# **JACK LONDON SQUARE REDEVELOPMENT PROJECT**

## *Final Environmental Impact Report*

*ER 03-0004  
SCH No. 2003022086*

## JACK LONDON SQUARE REDEVELOPMENT PROJECT FINAL ENVIRONMENTAL IMPACT REPORT

Attachments: Map of JACK LONDON DISTRICT ACCESS & EGRESS

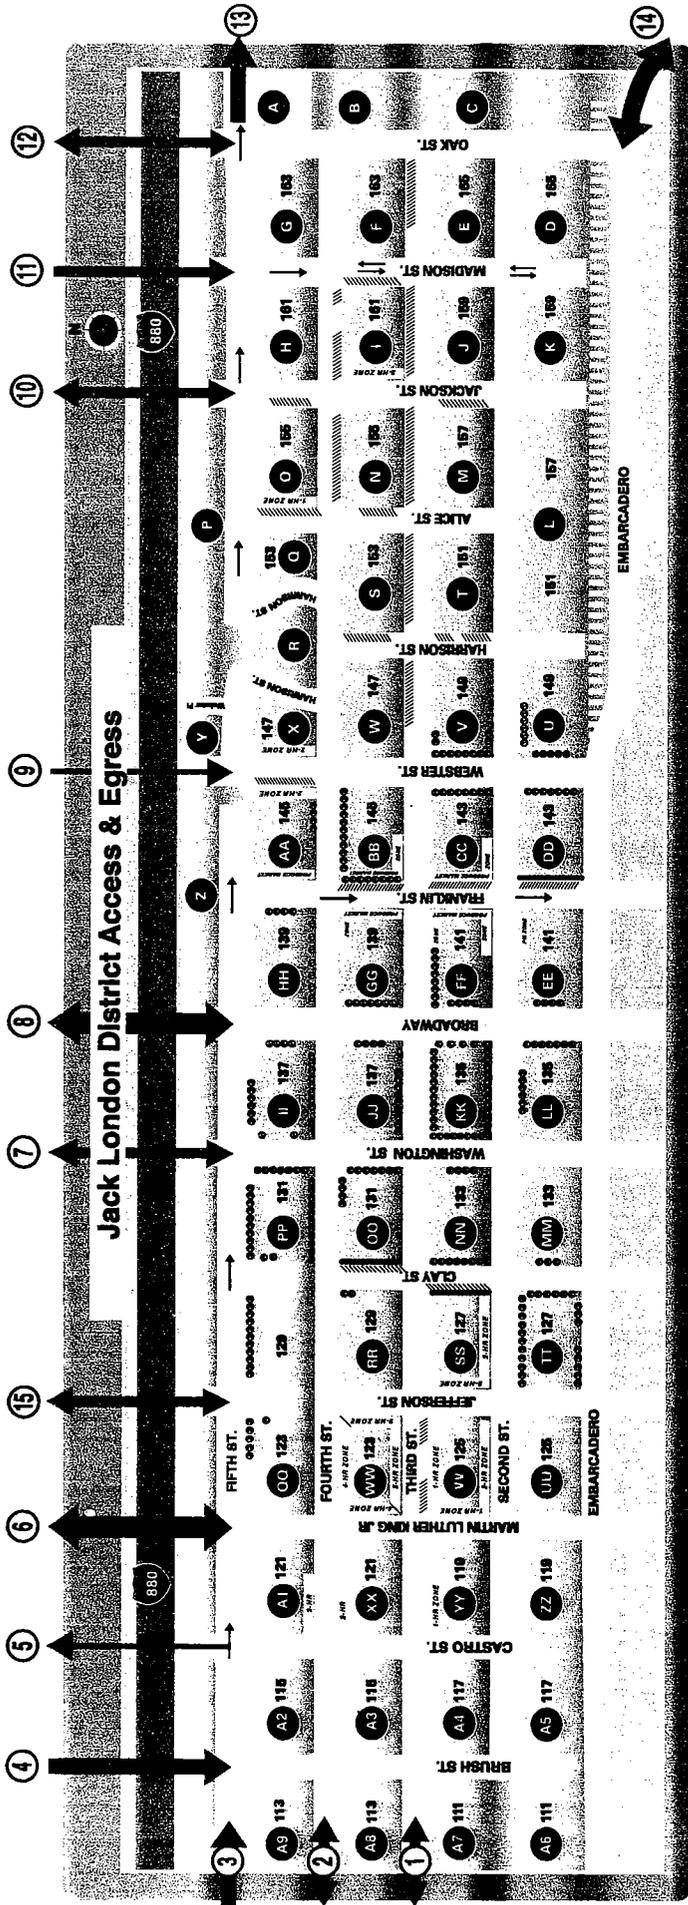
GATEWAYS TO JACK LONDON	LANES IN	LANES OUT	COMMENTS
1	3 <sup>rd</sup> @ Market	1	1	3 <sup>rd</sup> Street is a truck route and provides access from Oak to Port facilities, I-880, and West Oakland
2	4 <sup>th</sup> @ Market	1	1	4 <sup>th</sup> Street is a local street that runs from Oak to Market
3*	5 <sup>th</sup> @ Market	3	0	5 <sup>th</sup> Street feeds regional traffic to the Alameda tube, I-880, and the Jack London District
4	Brush @ 5 <sup>th</sup>	3	0	Brush feeds regional traffic from I-980 to 5 <sup>th</sup> (see above); signs on I-980 direct Jack London Square traffic onto Brush at 11 <sup>th</sup> Street
5	Castro @ 5 <sup>th</sup>	0	1	Castro has one lane exiting the district feeding into a 3-lane street accessing I-980 at 12 <sup>th</sup> Street
6	MLK @ 5 <sup>th</sup>	2	2	Martin Luther King, Jr Way has two lanes into and out of the district. Signals currently facilitate ingress and impede egress

Figure A

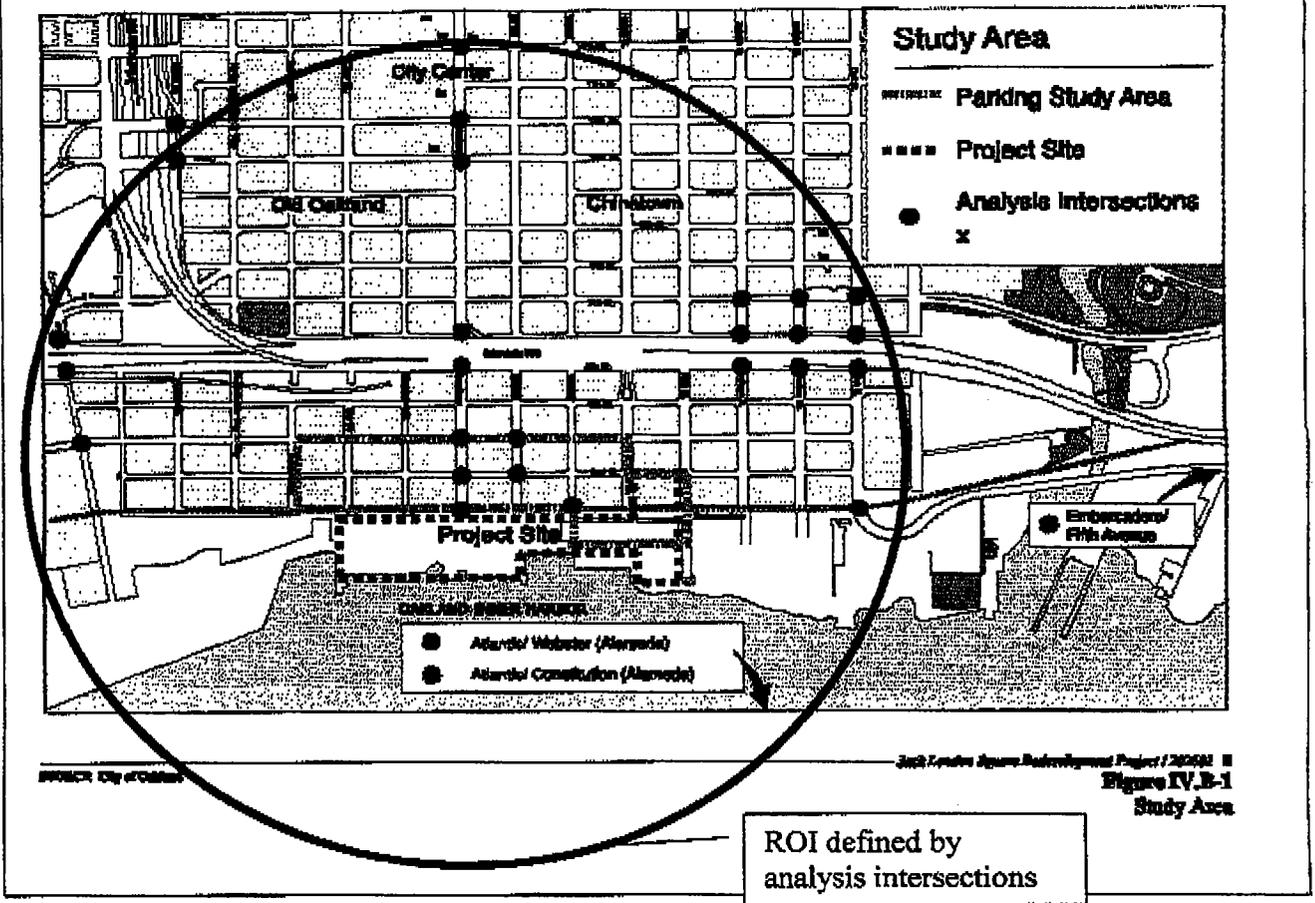
- The most compelling reason to include Chinatown intersections in the study area is that they will be heavily impacted by traffic bound for Alameda that is diverted by congestion on Broadway and 5<sup>th</sup>.

U-44

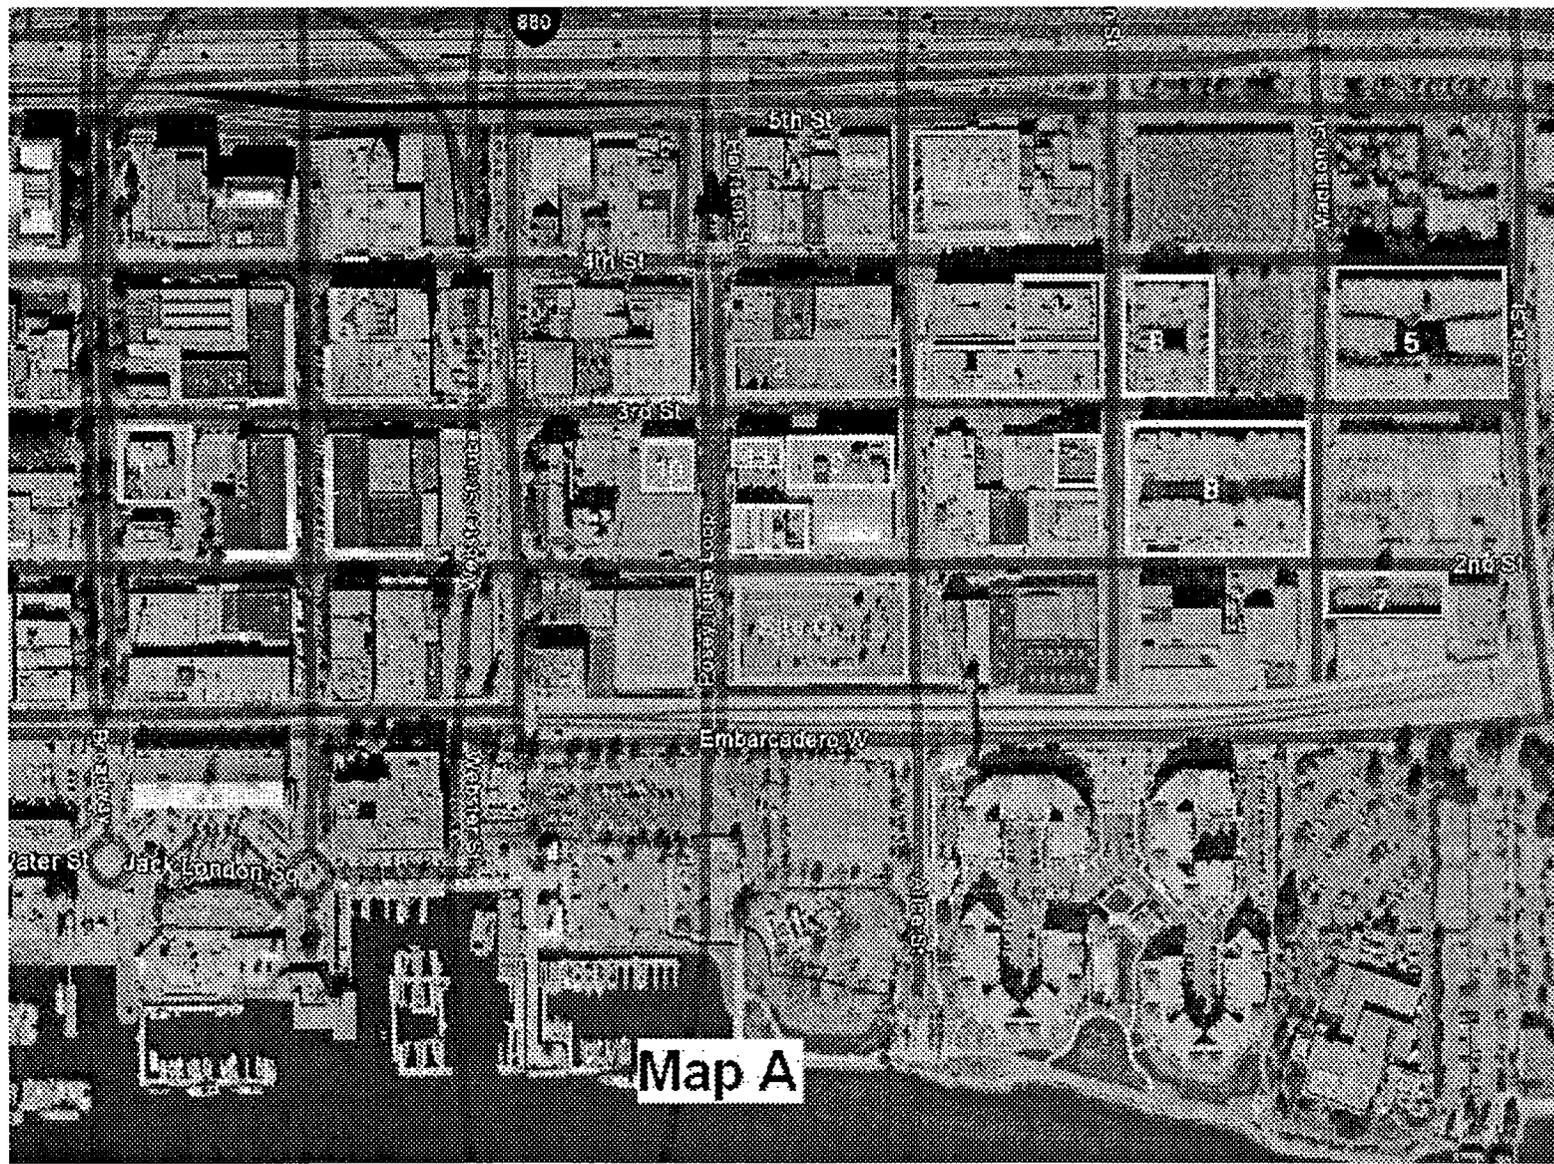
**I believe it is a grave error to consider the impacts of these two projects separately.**

The combined effect of a large retail and office development plus a large residential project that area almost adjacent and share the same access points to 880 and city streets is **clearly** going to be greater than the sum of the parts. A primary reason is that the Oak to Ninth Avenue project will be sufficiently far from many parts of the Jack London Square project that people in the Oak to Ninth Area will end up **driving** their cars towards the Washington Street garage. Hence the demand for parking will be much higher.

I believe the DEIR **must** consider the mitigations that will be usable by both projects such as, but not limited to:

Figure A

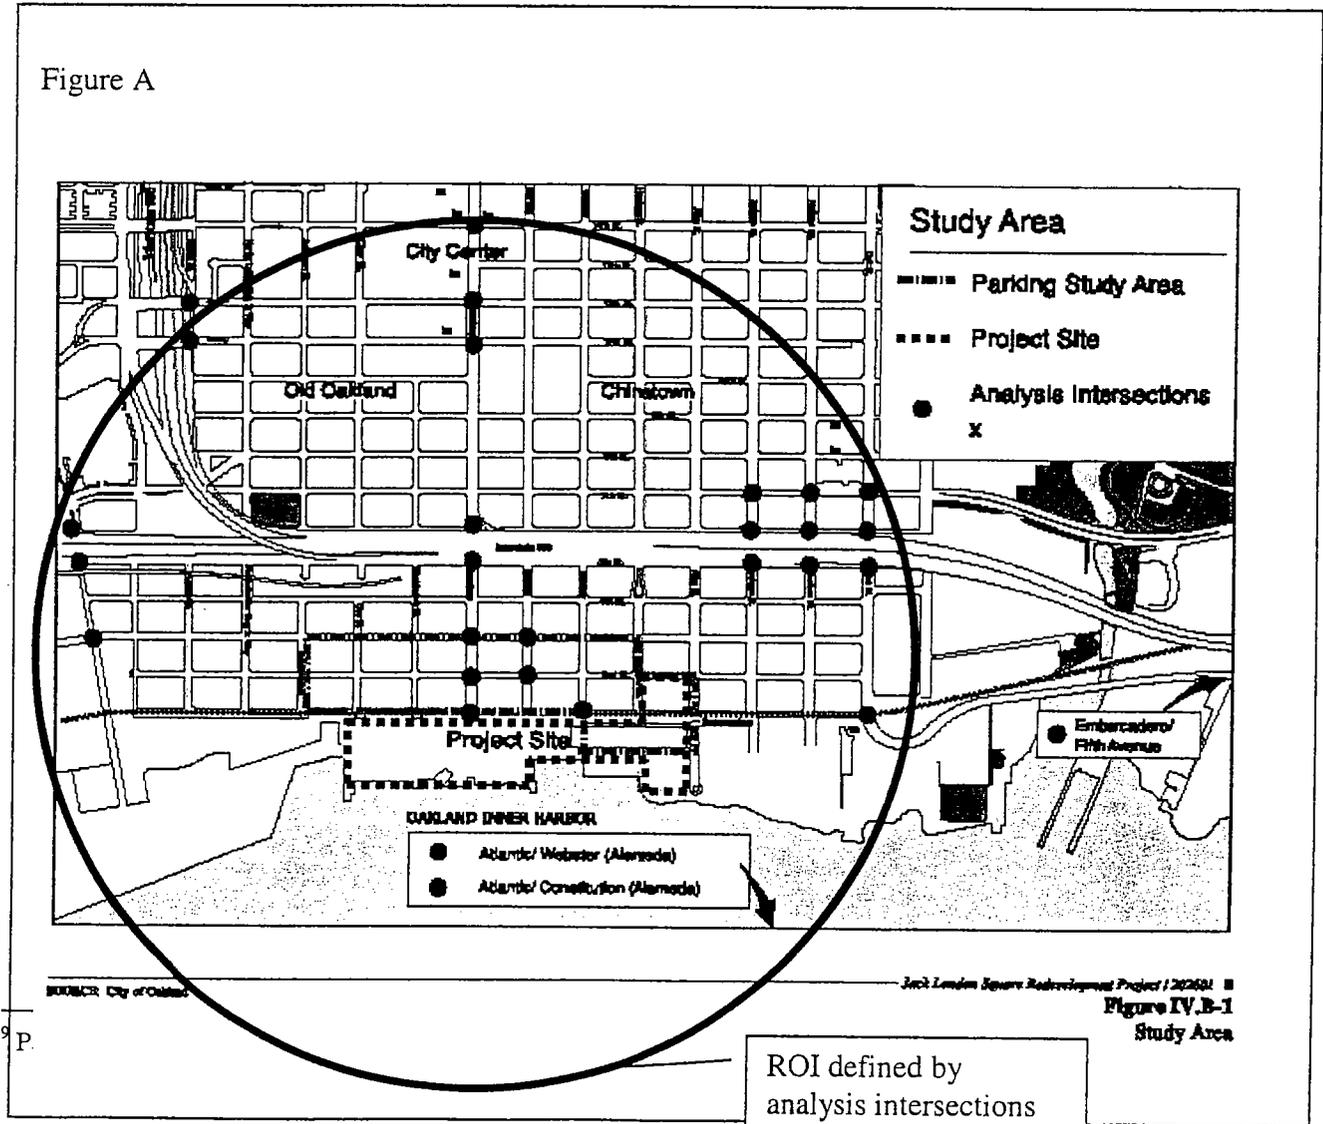
4. The most compelling reason to include Chinatown intersections in the study area is that they will be heavily impacted by traffic bound for Alameda that is diverted by congestion on Broadway and 5<sup>th</sup>. The DEIR explains that Project Phase I traffic will cause conditions at 5<sup>th</sup> and Broadway to deteriorate from existing LOS F during the PM peak hour, and that Phase II traffic will cause further deterioration, because of backups from the Webster Tube. Since vehicles traveling to Alameda have the option of entering the Tube from Webster Street, it is reasonable to assume that enough traffic will switch over to Webster until the delays at Webster intersections are equivalent to those at 5<sup>th</sup> and Broadway.

Webster is the obvious alternate route since it connects with Grand, which in turn links to both 980 and 580. We are not in favor of Webster taking on an additional burden for Alameda traffic, given projections of Project traffic we recognize that it will be inevitable unless there are serious mitigation efforts.
